RESPONSE TO REQUEST FOR ADDITIONAL INFORMATION

APR1400 Design Certification

Docket No. 52-046

RAI No.: 493-8621
SRP Section: 09.02.01 - Station Service Water System
Application Section: 9.2.1
Date of RAI Issue: 05/31/2016

Figure 9.2.1-1 Essential Service Water System Flow Diagram

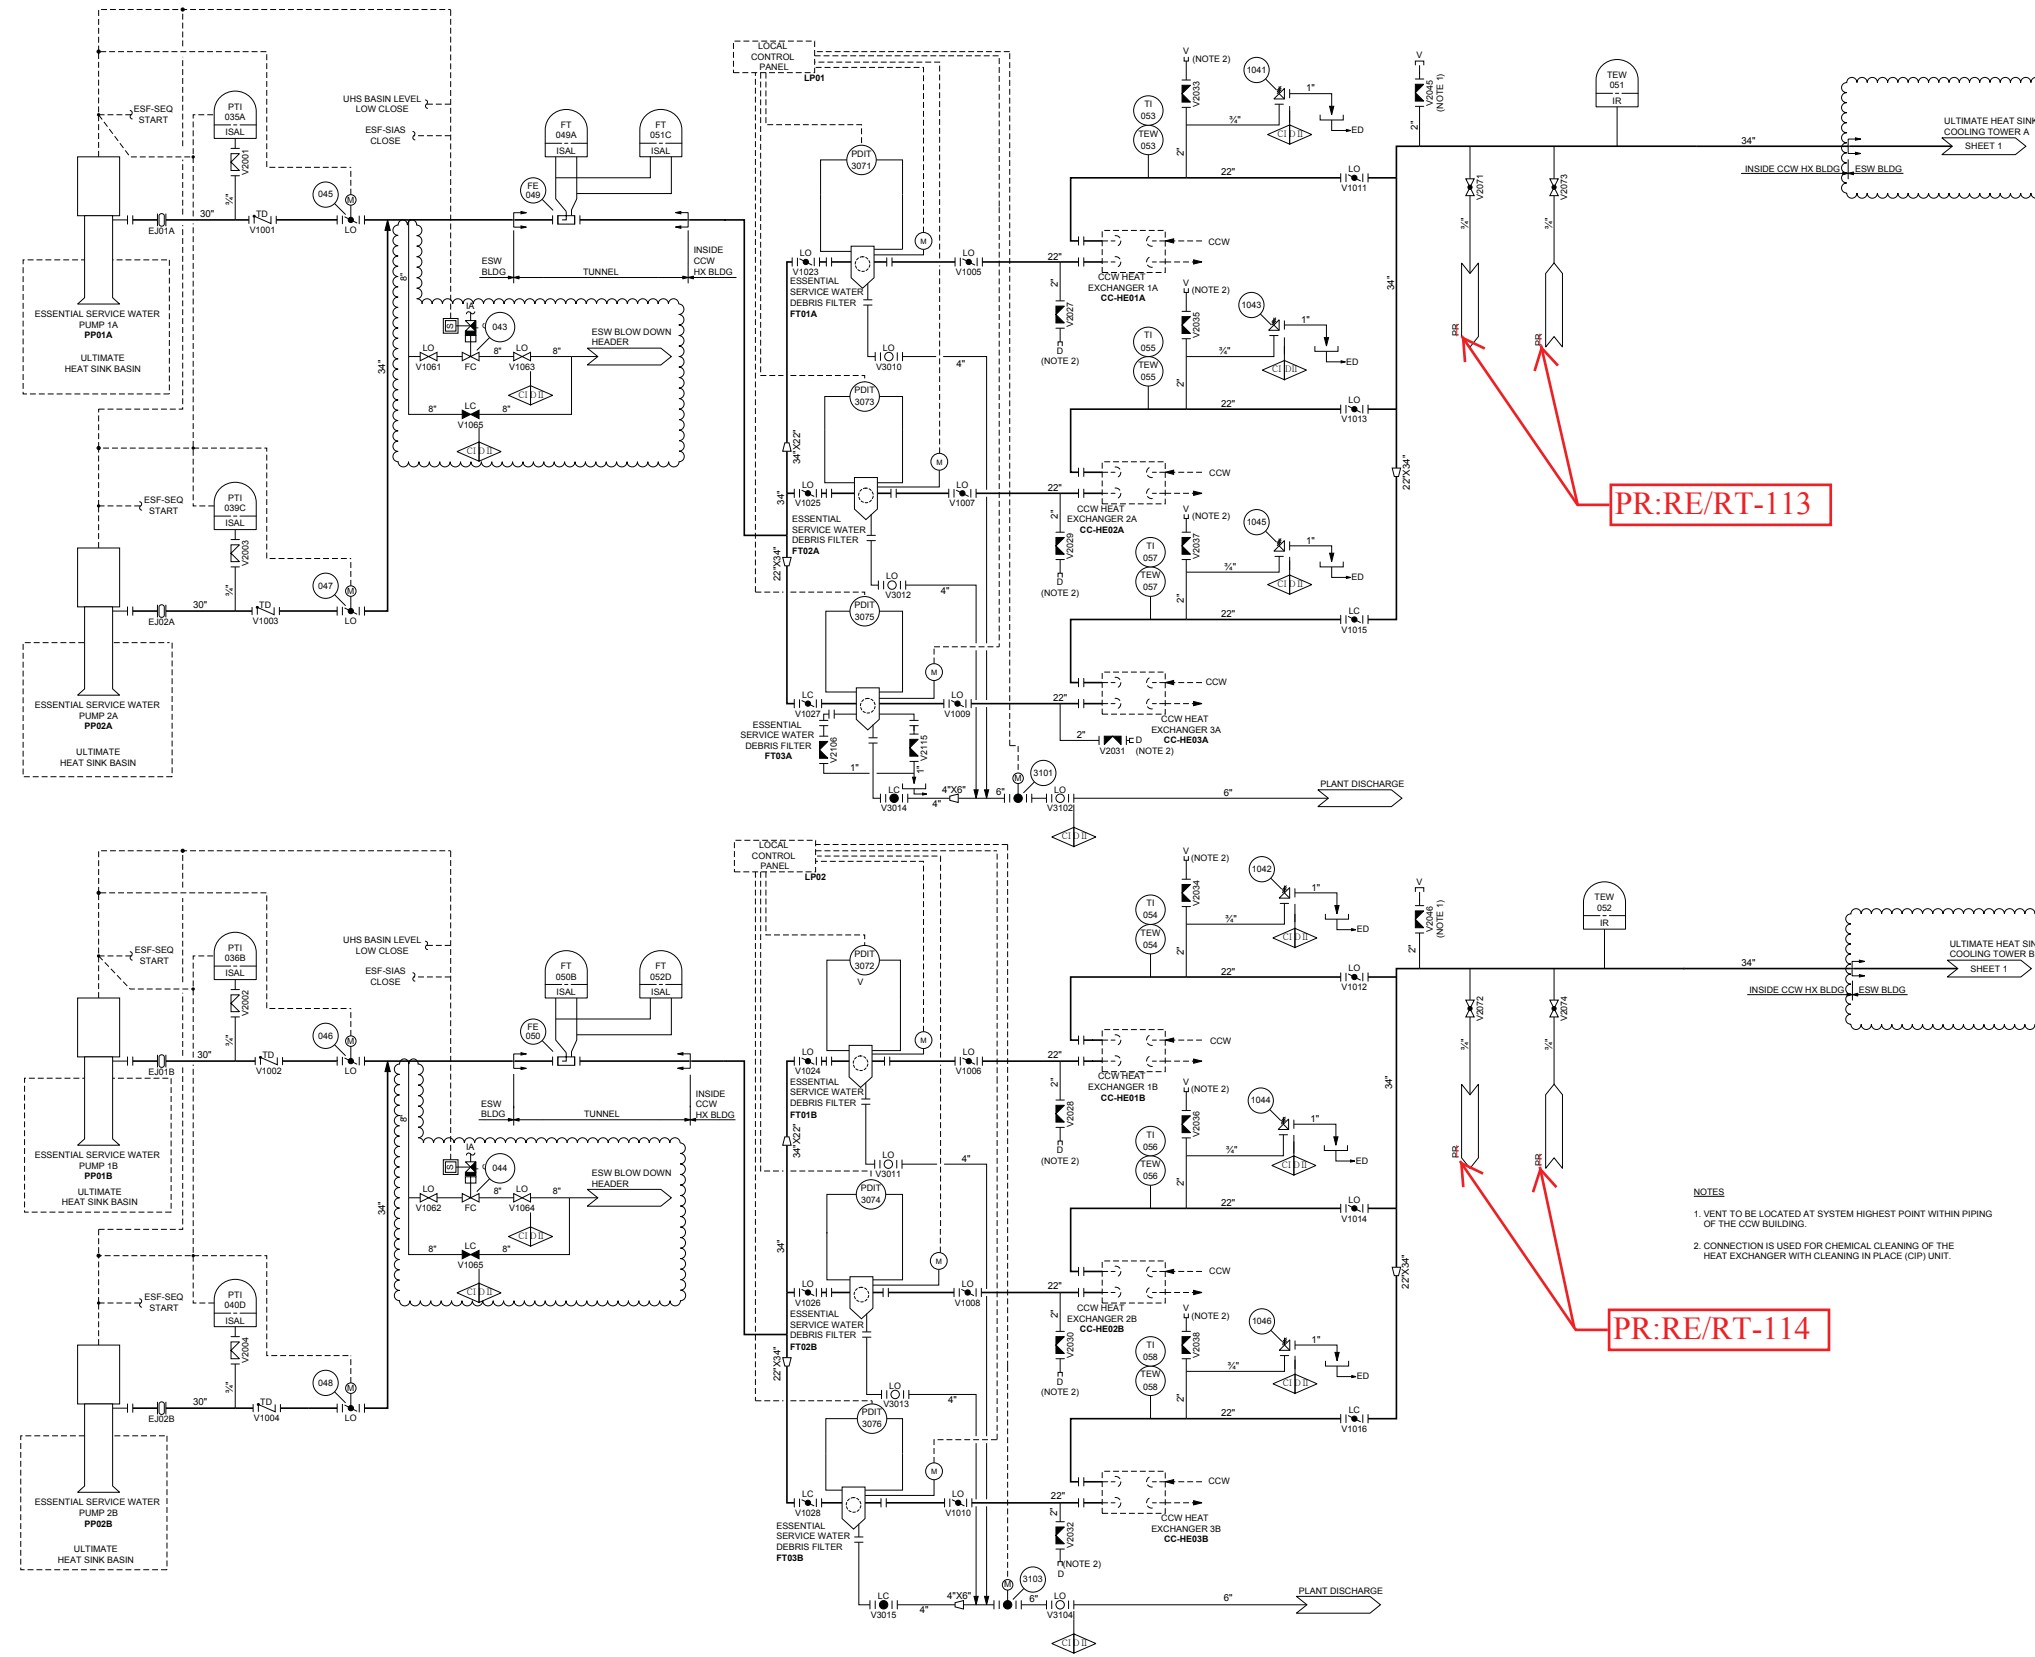
The NRC staff reviewed the response and determined it is incomplete. SRP Section 9.2.1 Subsection III.3.D asks that the ESWS system piping and instrumentation diagrams (P&IDs) show radiation monitors located on the system discharge and at components susceptible to leakage, and these components can be isolated by one automatic and one manual valve in series. The staff reviewed the P&ID of Figure 9.2.1-1 and the RAI response, and could not find the above information. The applicant is requested to provide the isolation valve information and radiation monitors in the P&ID in accordance with the SRP guidance.

Prior to any radiation leakage being detected in the ESWS, radiation alarms on the CCWS side alerts the operators of contamination in the CCWS. The affected CCWS division is immediately isolated followed by the isolation valves (V1005 ~ V1016) on the inlet and outlet lines of the CCW heat exchanger cold side (ESW) to prevent possible contamination of the UHS and the environment.

PR of Figure 9.2.1-1 in DCD Tier 2 will be corrected to PR: RE/RT-113, 114 in accordance with Figure 11.5-1.

Figure 9.2.1-1 of DCD Tier 2 will be revised as indicated in Attachment.
